CNRO-2003-00057

SUBJECT: Entergy Operations, Inc.
Response to a Request for Additional Information Pertaining to
Relaxation Request to NRC Order EA-03-009 for the Control Element
Drive Mechanism Nozzles

Waterford Steam Electric Station, Unit 3
Docket No. 50-382
License No. NPF-38

RESPONSE TO A REQUEST FOR ADDITIONAL INFORMATION

ECT INSPECTION TOOL FOR CEDM NOZZLE BLIND ZONE

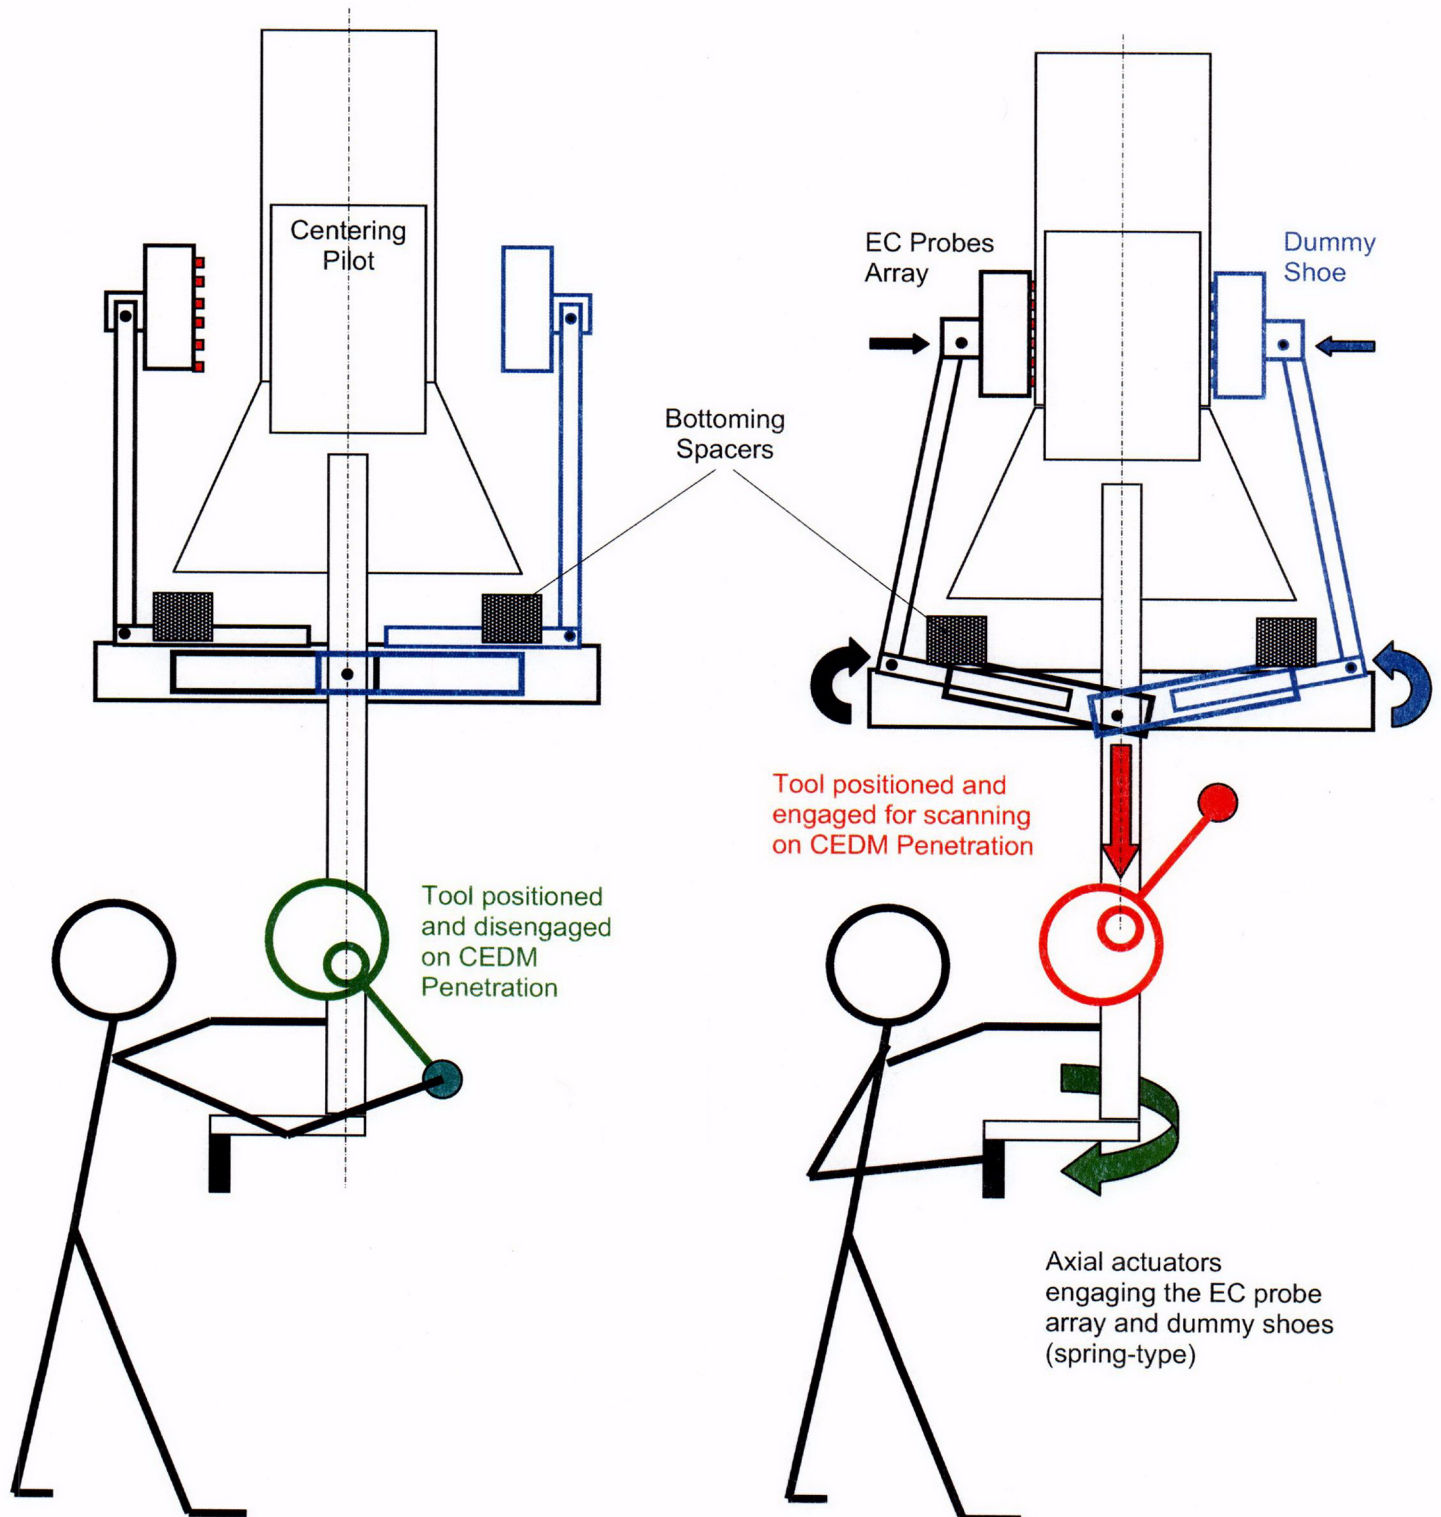
Please provide a description of the eddy current testing (ECT) instrumentation to be utilized in the augmented inspections of the CEDM nozzle blind zone area, if required.

The planned ECT inspection tool (sled) is designed with arrayed "plus point" ECT coils that allow a single scan to be performed without multiple setups. Scan lengths prevent interference issues associated with the guide cones and steep angles on the outer nozzle rows. The scan length is fixed by the design of the inspection tool and the size of the ECT coil block. The position of the ECT coil block is fixed relative to the vertical axis of the nozzle.

If utilized, the ECT inspection equipment is manually installed on each CEDM nozzle and manually operated. The ECT equipment can inspect the nozzle from the top of the blind zone down 0.8 inch.

Figure 3: 29.1° nozzle showing the differences between as-designed and the as-analyzed based on sister plant UT data.

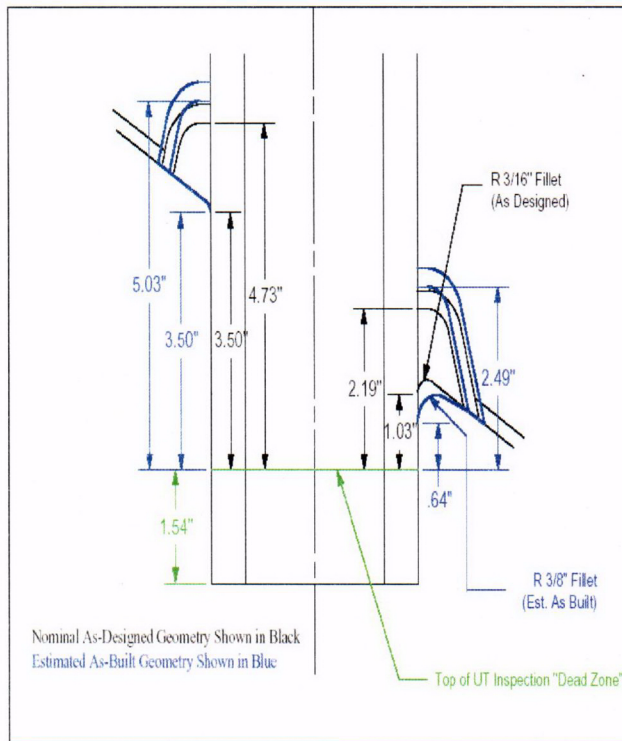
The analysis used to support the Waterford 3 Relaxation Request #1 was based on ultrasonic testing (UT) data from a sister plant. What as-found conditions, based on the planned UT inspections of the CEDM nozzles would necessitate reanalysis to ensure compliance with NRC Order EA-03-009?

Figures 3 and 4 show the evaluation results for the nozzle groups in the middle region (29.1°) and the outermost region (49.7°). These figures indicate the following:

- The weld length along the nozzle bore has increased;
- The available propagation length on the uphill side remains unchanged; and
- The fillet-cap weld size on the downhill side has increased.

The increase of the fillet-cap weld size on the downhill side, in-turn, reduces the available propagation length. This reduction in the available propagation length will have an impact on the fracture mechanics analysis that assesses the effect of the blind zone.
